**AIP 3-22-0006-128-2023 & H.015713**  
**TAXIWAY LIMA EXTENSION AND DECOMMISSIONING OF GA RUNWAY 4R-22L AND TAXIWAY ECHO**  
BATON ROUGE METROPOLITAN AIRPORT

**ADDENDUM NO. 1**

**DATE ISSUED: JULY 18, 2024**

**2**  
TS2  
**PROPOSED TAXIWAY TYPICAL SECTION**  
SCALE: NOT TO SCALE  
STA. 520+85.41 TO STA. 534+01.96  
STA. 534+76.96 TO STA. 537+64.05  
STA. 539+14.05 TO STA. 542+48.12  
STA. 543+39.60 TO STA. 557+81.83  
STA. 558+55.83 TO STA. 582+82.50

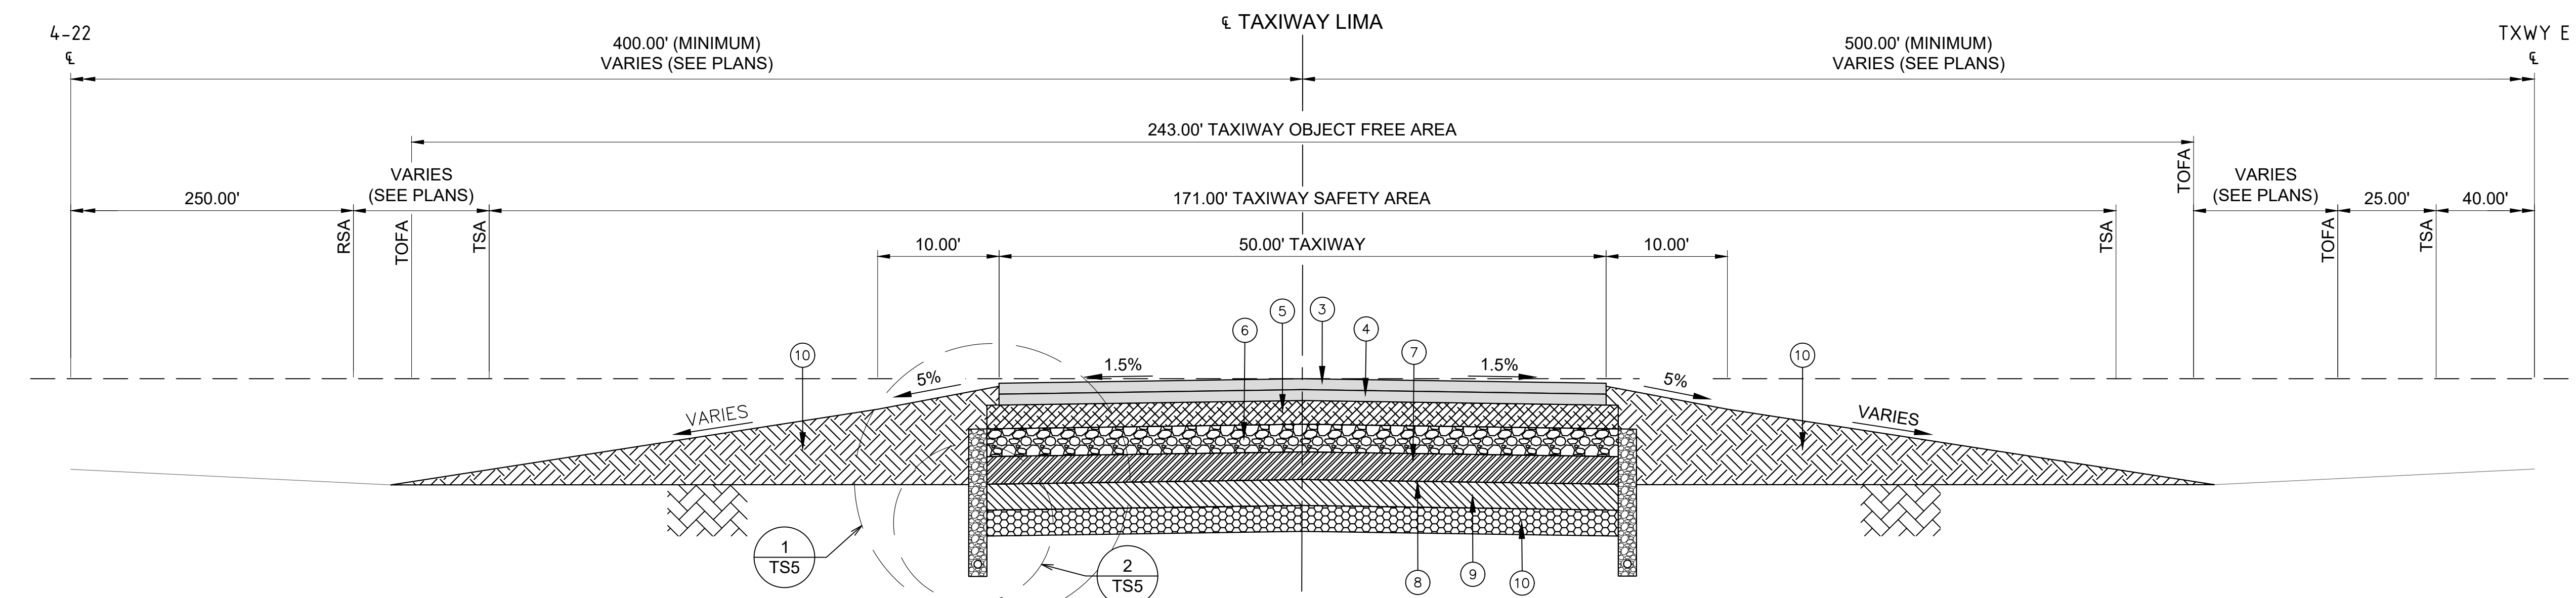
7/17/2024	Douglas Olson	Barriere Construction Co., LLC	Plan Sheet TS2 Typical section shows Geosynthetic Fabric between the P-154 Subbase and the P-407 Asphalt Treated Permeable Base. Plan Sheet TS2 Note 3 Geosynthetic Fabric shall be included in with cost P-154 Subbase Course. Proposal form has a pay item P-209-5.2 Separation Fabric 22,286 sy Section P-209 Crushed Aggregate base includes section. 209-2.4 Separation Geotextile. Separation geotextile shall be Class 2, 0.02 sec-1 permittivity per ASTM D4491, Apparent opening size per ASTM D4751 with 0.60 mm maximum average roll value. The section clearly states payment under item P-209-5.2 Section 154-2 Subbase Course includes section 154-2.3 Separation Geotextile. Separation geotextile shall be Class 2; 0.02 sec-1 permittivity per ASTM D4491; Apparent opening size per ASTM D4751 with 0.60 mm maximum average roll value. Please clarify the location of the Geotextile fabric and that it is paid under item P-209-5.2	7/16/2024	Note 3 will be removed from the applicable typical sections. Fabric will be paid under Item P-209-5.2.	Adam Fields

**TAXIWAY LIMA EXTENSION**  
**PROPOSED DEMOLITION PLAN - AREA B2D**

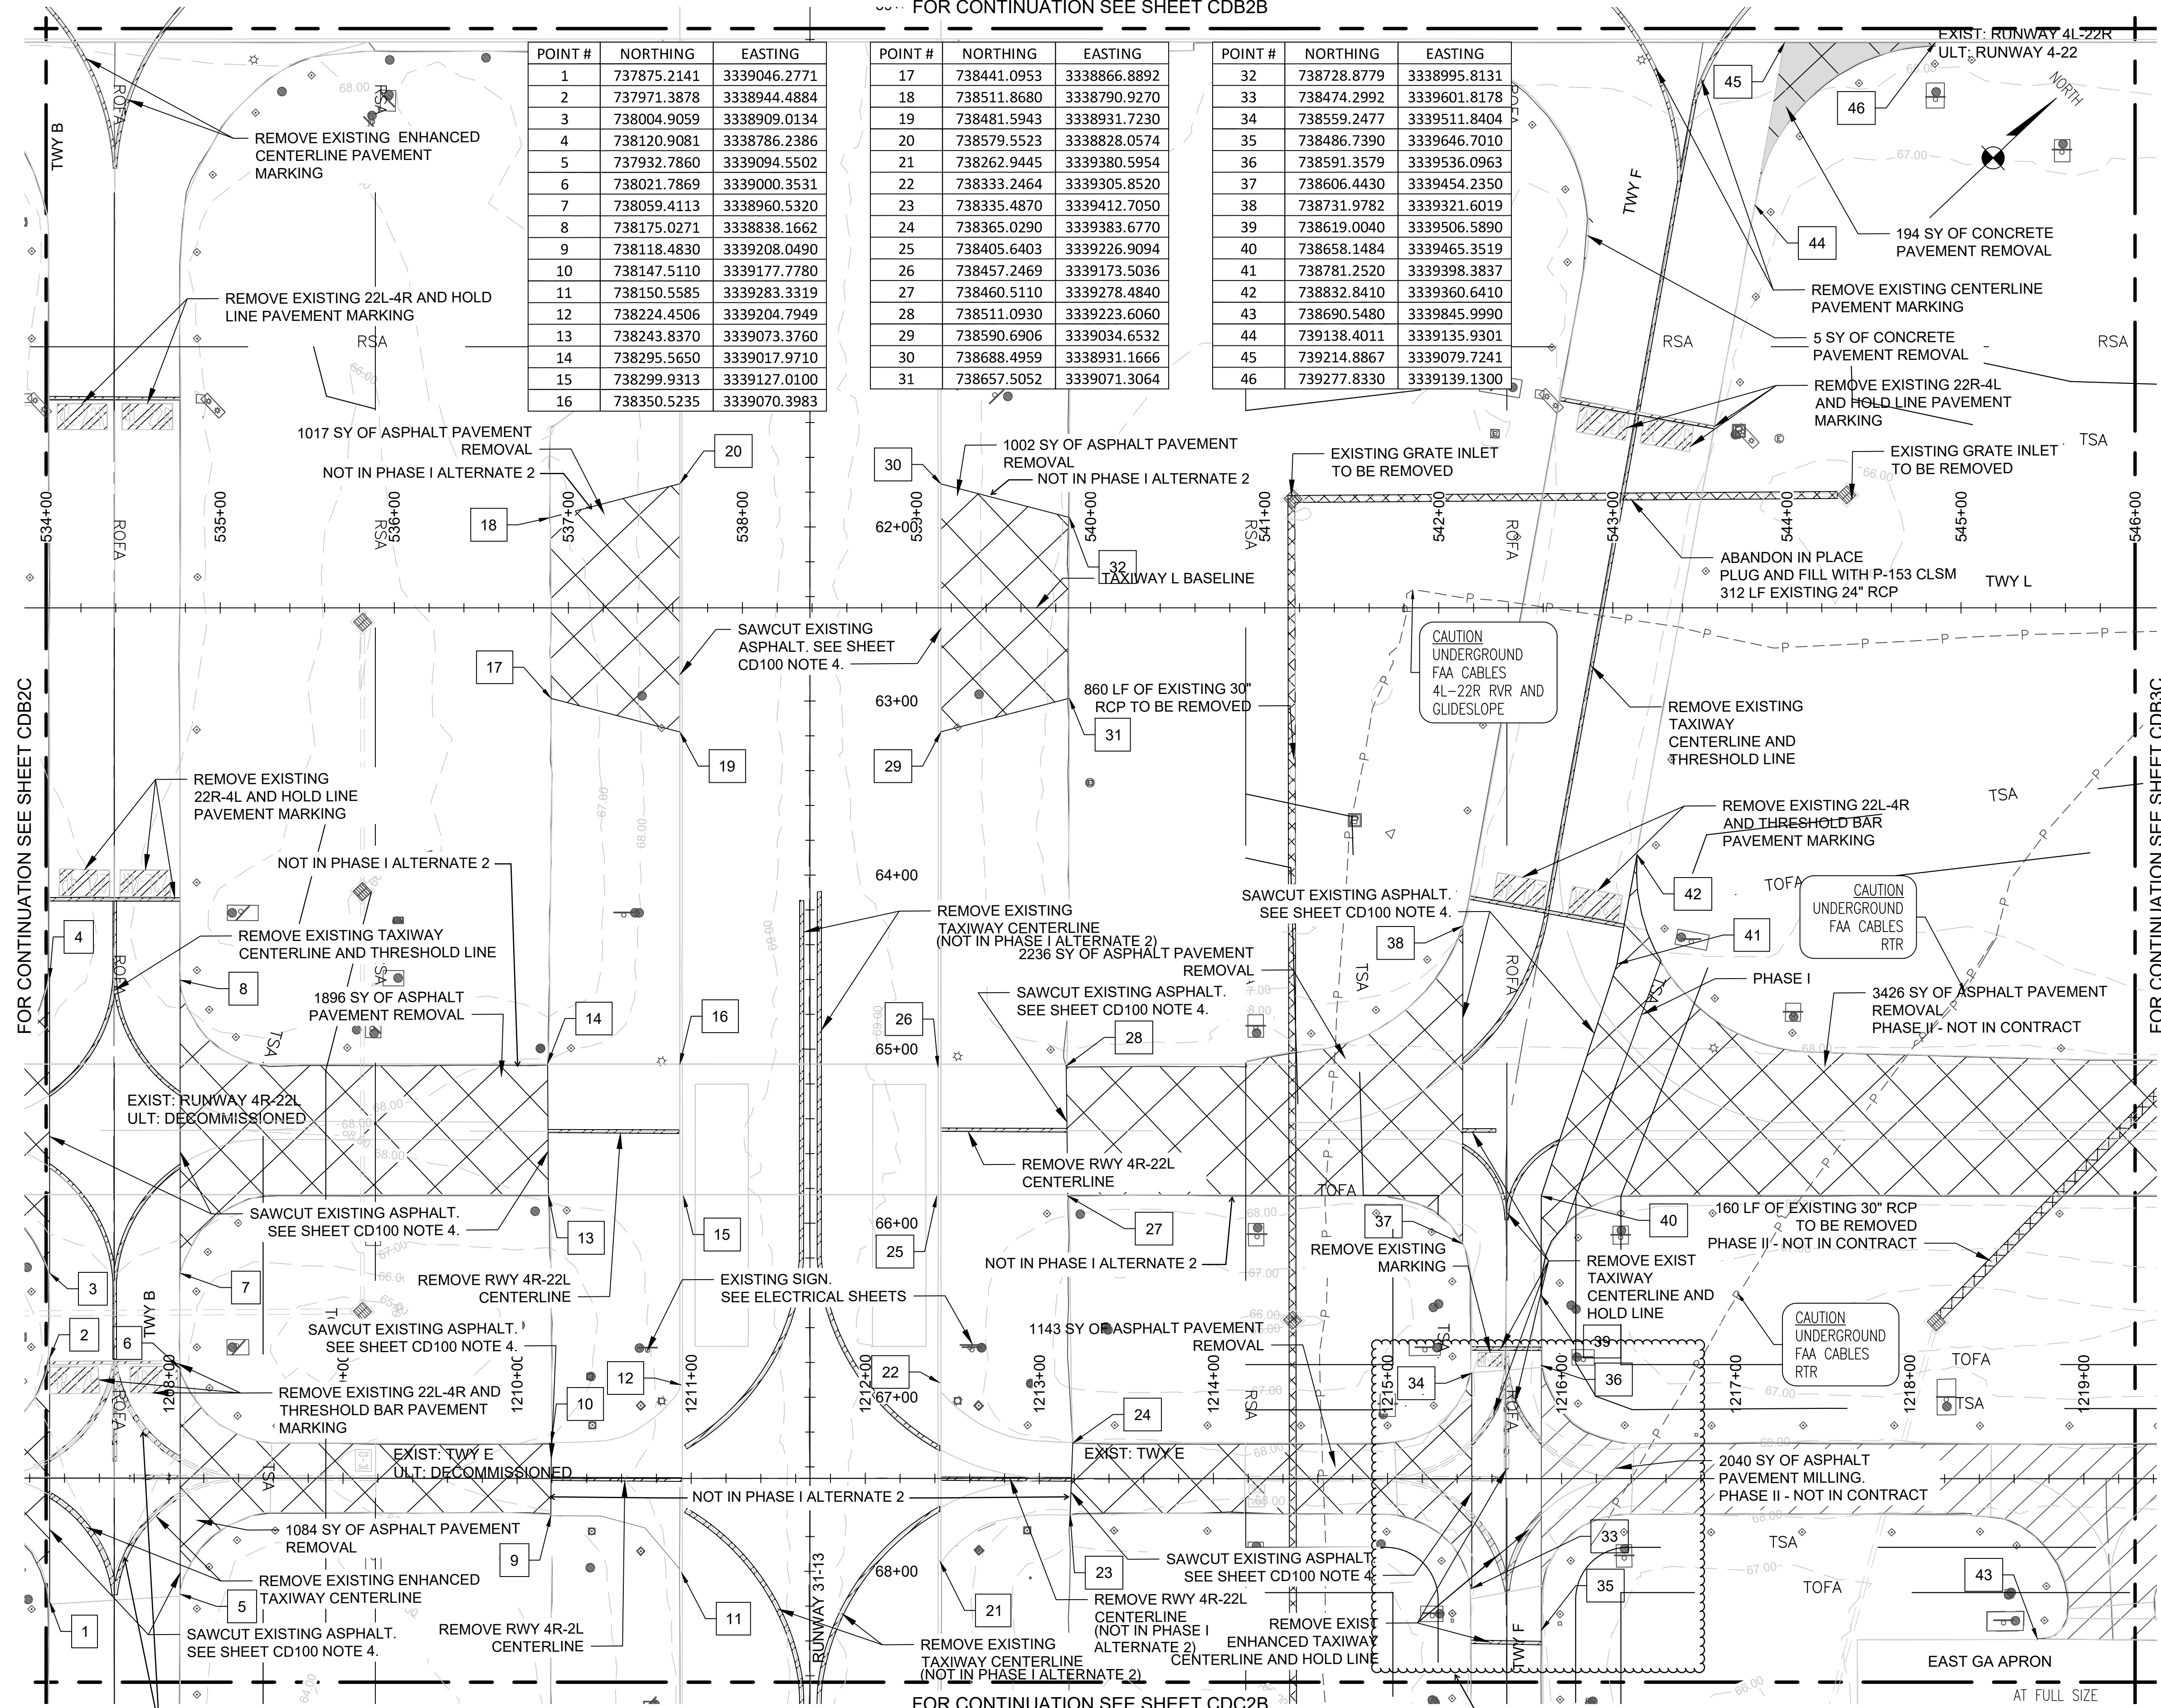
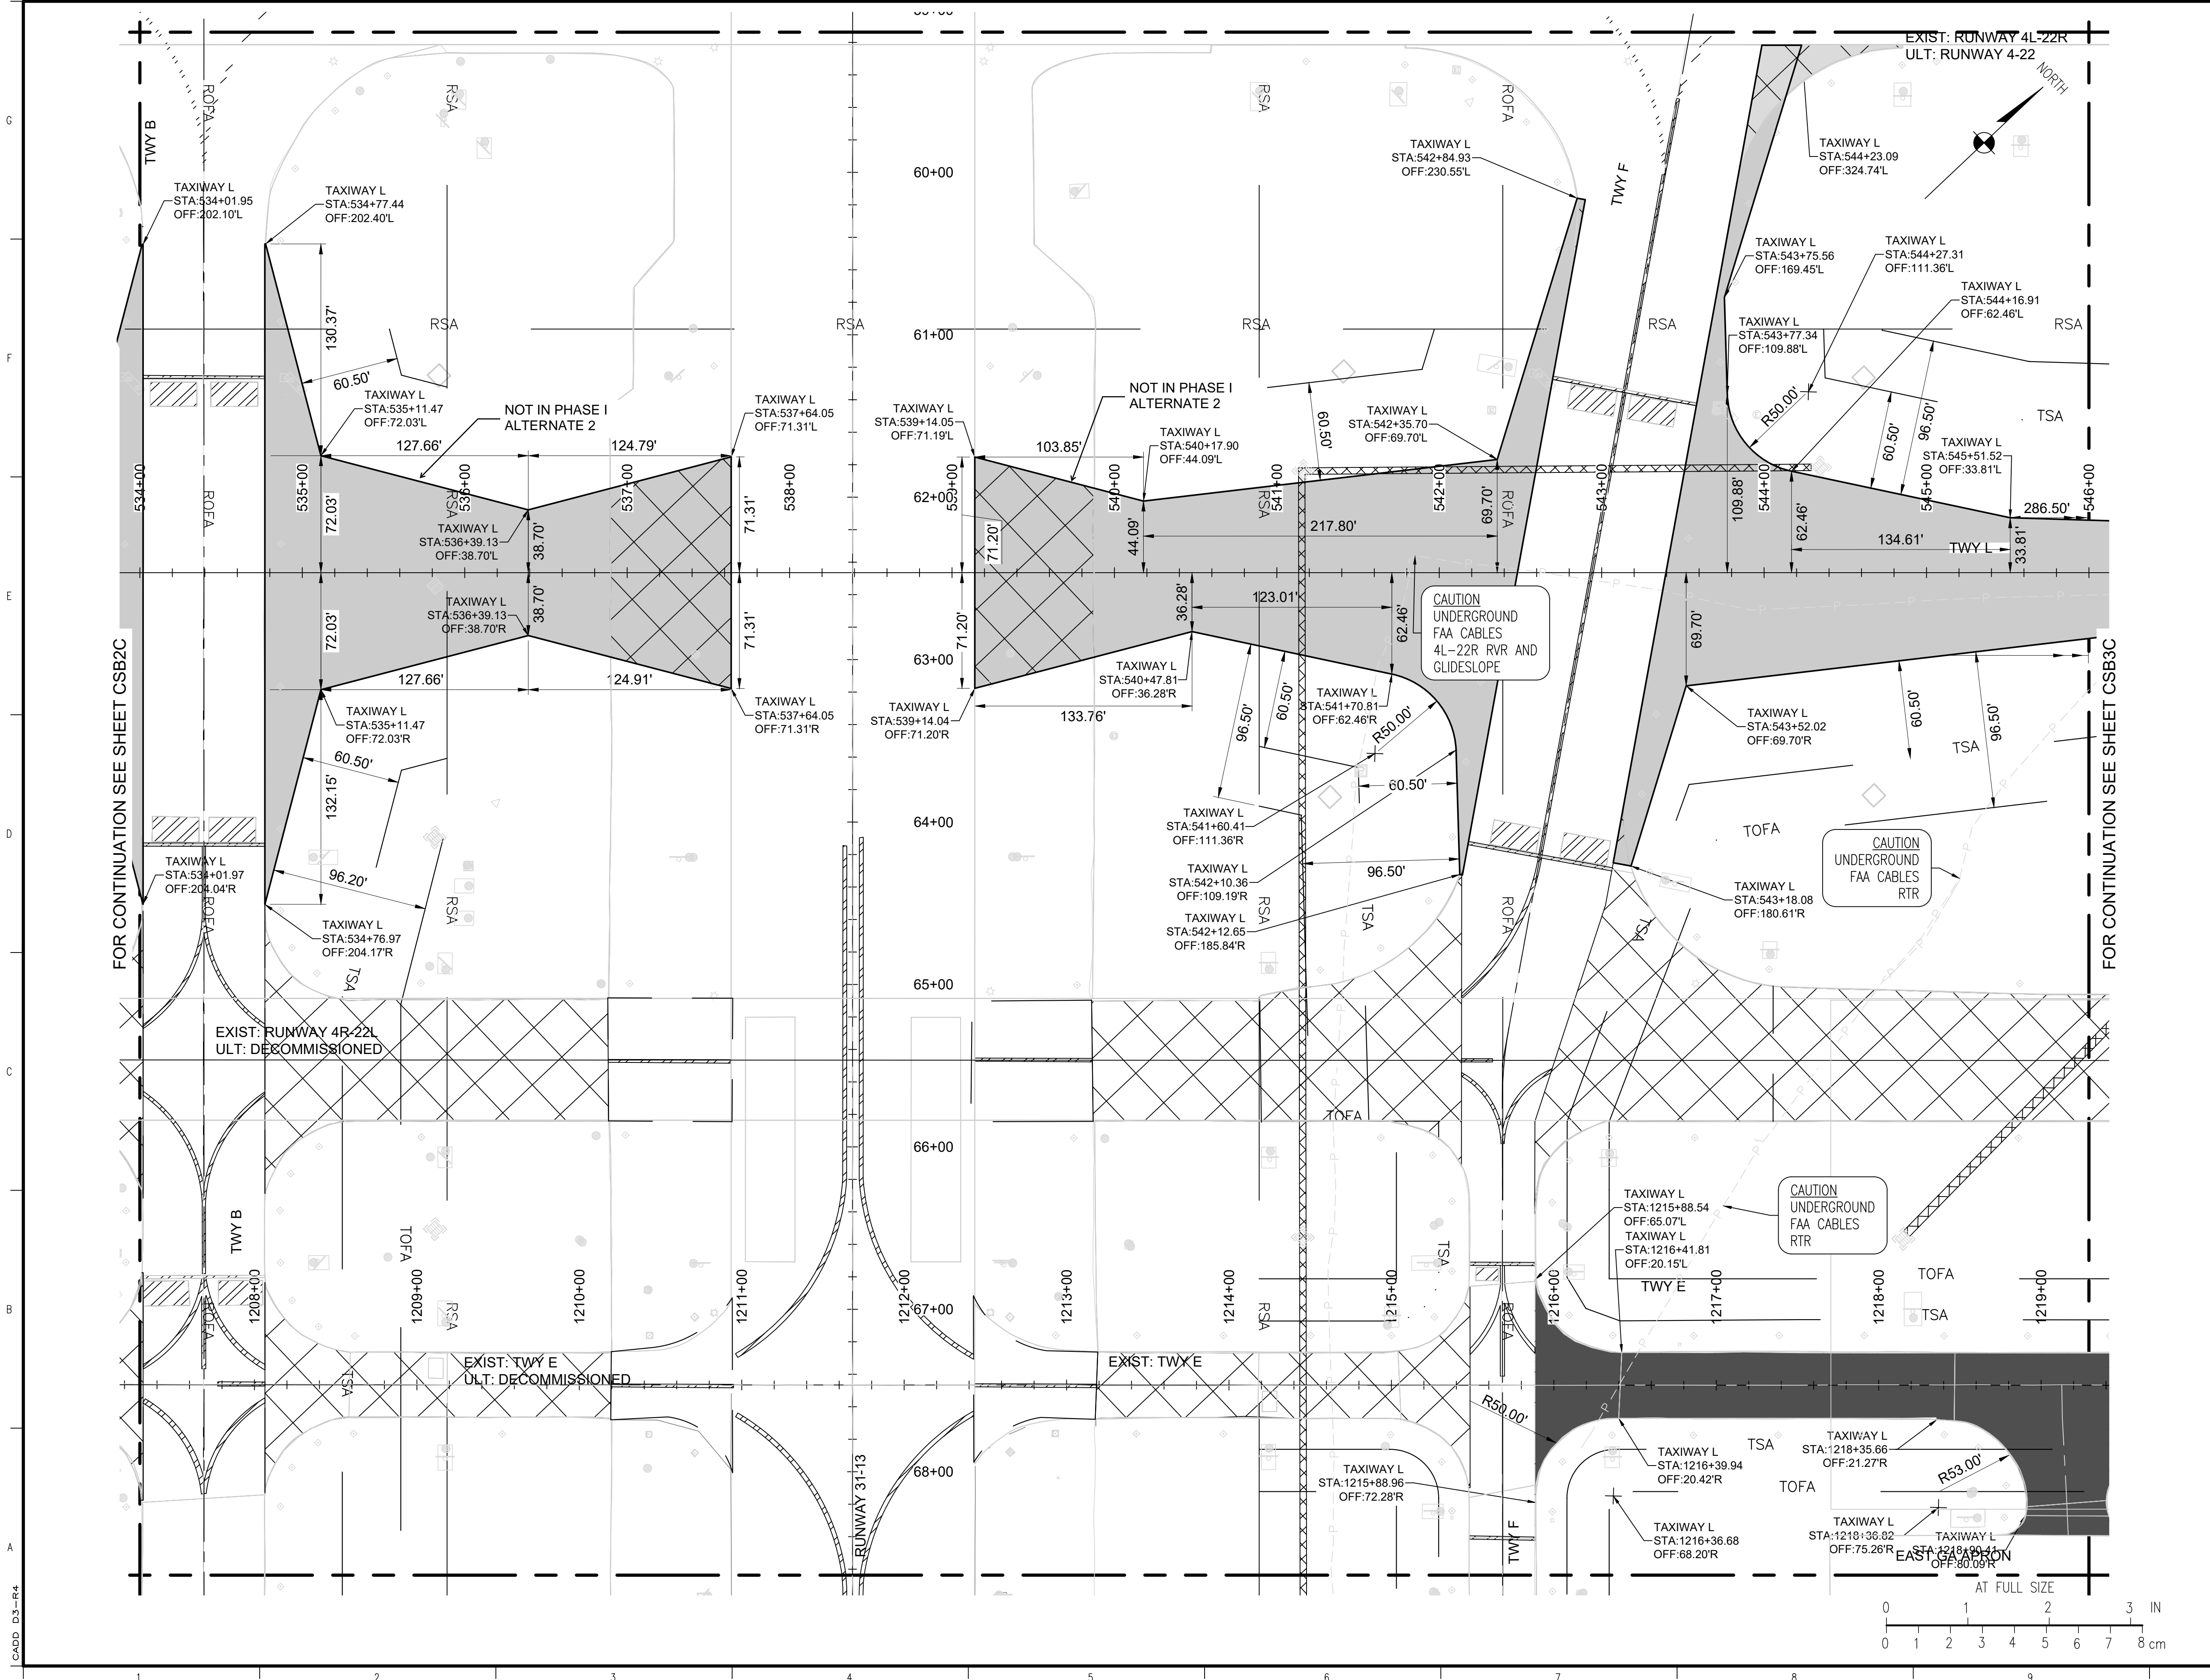
- SEE SHEET CD100 FOR DEMOLITION NOTES.
- WORK NORTH OF TAXIWAY B NOT INCLUDED IN PHASE I ALTERNATE 2.
